WELL API NO. 30-025-22766
5. Indicate Type of Lease STATE <input checked="" type="checkbox"/> FEE <input type="checkbox"/>
6. State Oil & Gas Lease No. E-2519
7. Lease Name or Unit Agreement Name: East E-K Queen Unit
7. Well No. 10
9. Pool name or Wildcat E-K Queen; East

SUNDRY NOTICES AND REPORTS ON WELLS
 (DO NOT USE THIS FORM FOR PROPOSALS TO DRILL OR TO DEEPEN OR PLUG BACK TO A DIFFERENT RESERVOIR. USE "APPLICATION FOR PERMIT" (FORM C-101) FOR SUCH PROPOSALS.)

NOTICE OF INTENTION TO:		SUBSEQUENT REPORT OF:	
PERFORM REMEDIAL WORK <input type="checkbox"/>	PLUG AND ABANDON <input checked="" type="checkbox"/>	REMEDIAL WORK <input type="checkbox"/>	ALTERING CASING <input type="checkbox"/>
TEMPORARILY ABANDON <input type="checkbox"/>	CHANGE PLANS <input type="checkbox"/>	COMMENCE DRILLING OPNS. <input type="checkbox"/>	PLUG AND ABANDONMENT <input type="checkbox"/>
PULL OR ALTER CASING <input type="checkbox"/>	MULTIPLE COMPLETION <input type="checkbox"/>	CASING TEST AND CEMENT JOB <input type="checkbox"/>	
OTHER: <input type="checkbox"/>		OTHER: <input type="checkbox"/>

- P&A Wellbore Diagram
 East E-K Queen # 10

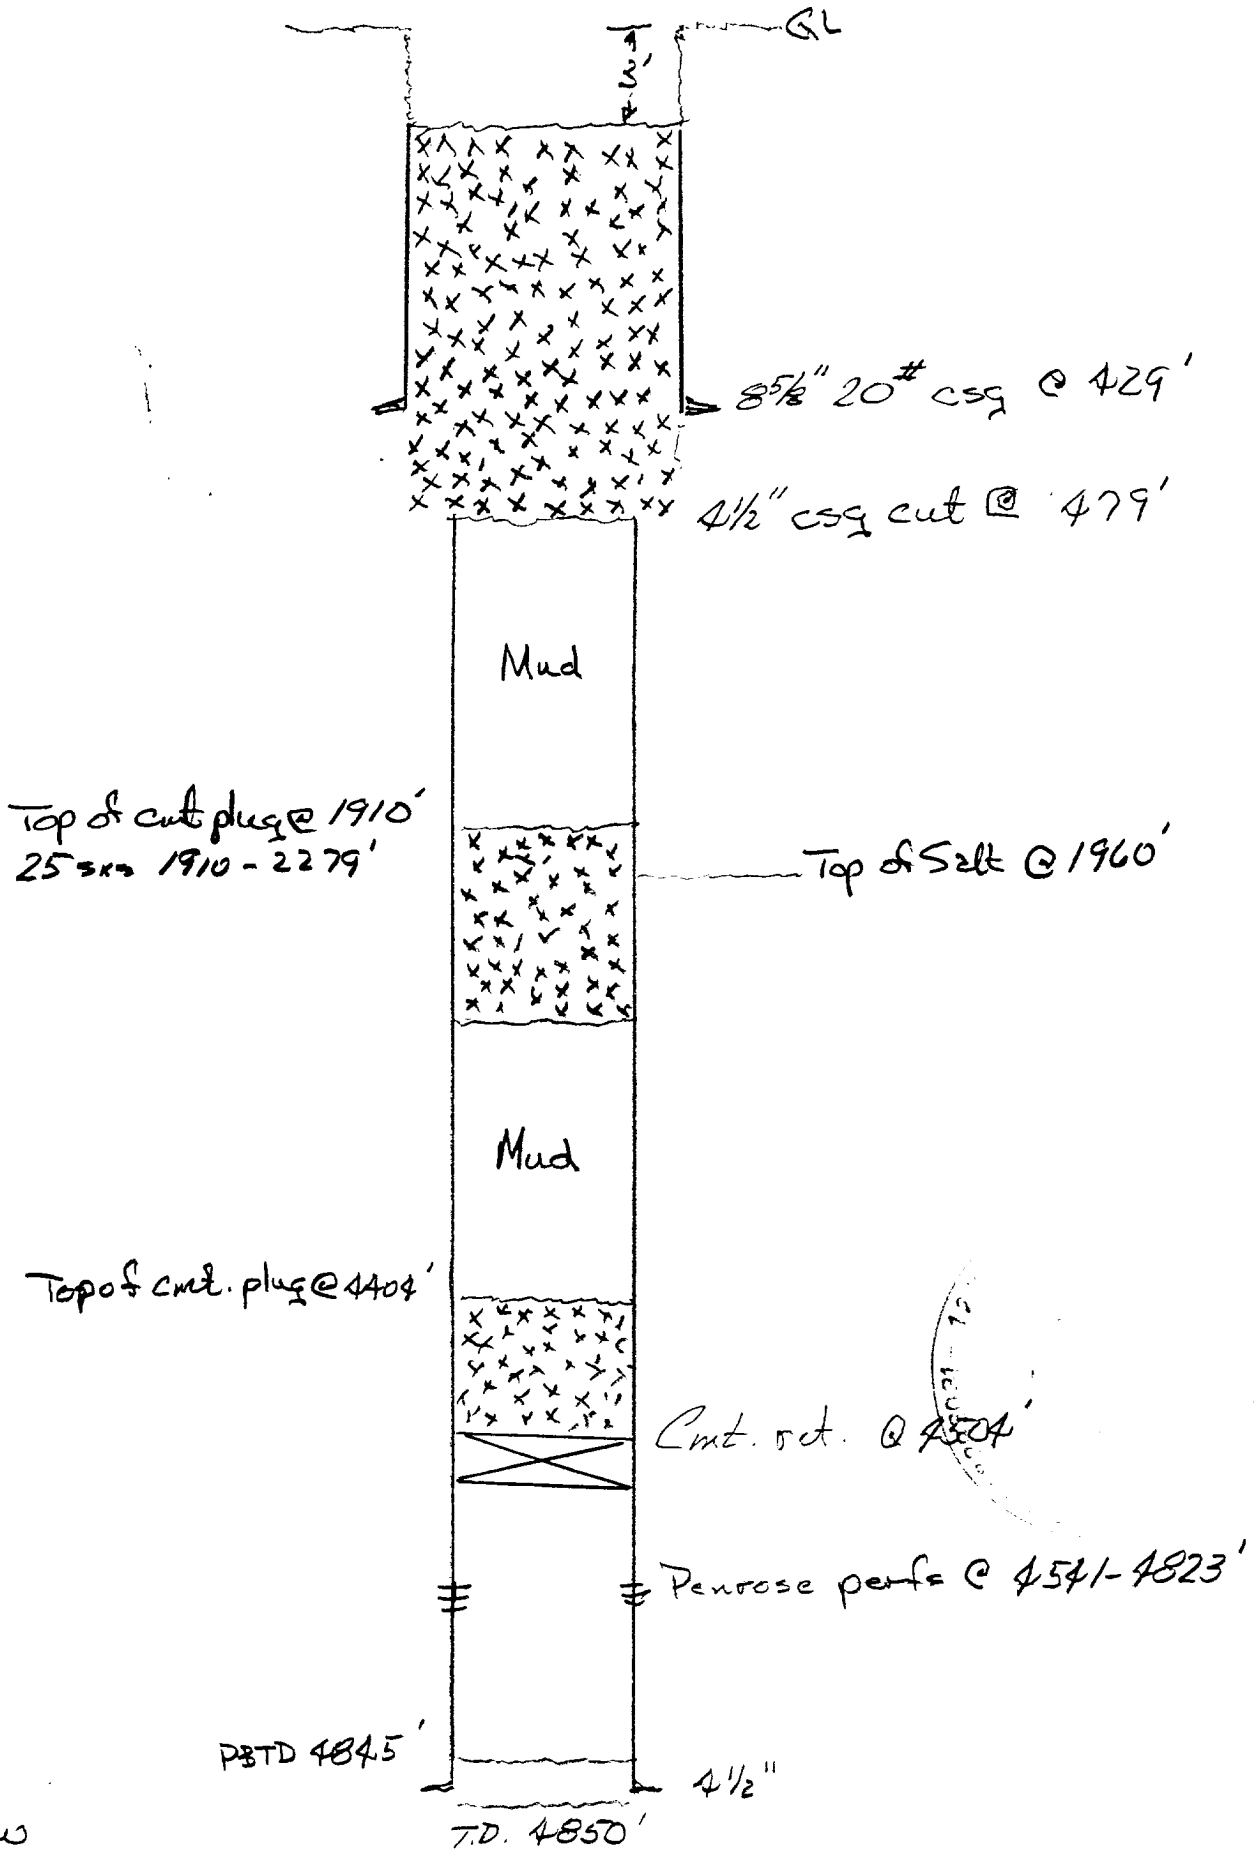
- MIRU. RIH w/ 2 7/8" tubing work string and tag cement retainer at 4504 ft. Spot cement plug on retainer from 4504 to 4404 ft. (6.8 sxs cement) This plug must be tagged.
- Spot mud from 4404 to 2279 ft. (33.8 bbls)
 → SPOT 100' CEMENT PLUG F/3195' to 3095' (BASE OF SALT)
- Spot 25 sxs cement plug from 2279 to 1910 ft. (50 ft. above the top of salt)
- Spot mud from 1910 to 479 ft. (22.75 bbls) Well must be in compliance with Rule 201 by 11/11/02.

APPROVED BY Gary W. Wink ORIGINAL SIGNED BY GARY W. WINK
 Conditions of approval, if any: OC FIELD REPRESENTATIVE W/ STATE MISC. APPT. DATE SEP 12 2002
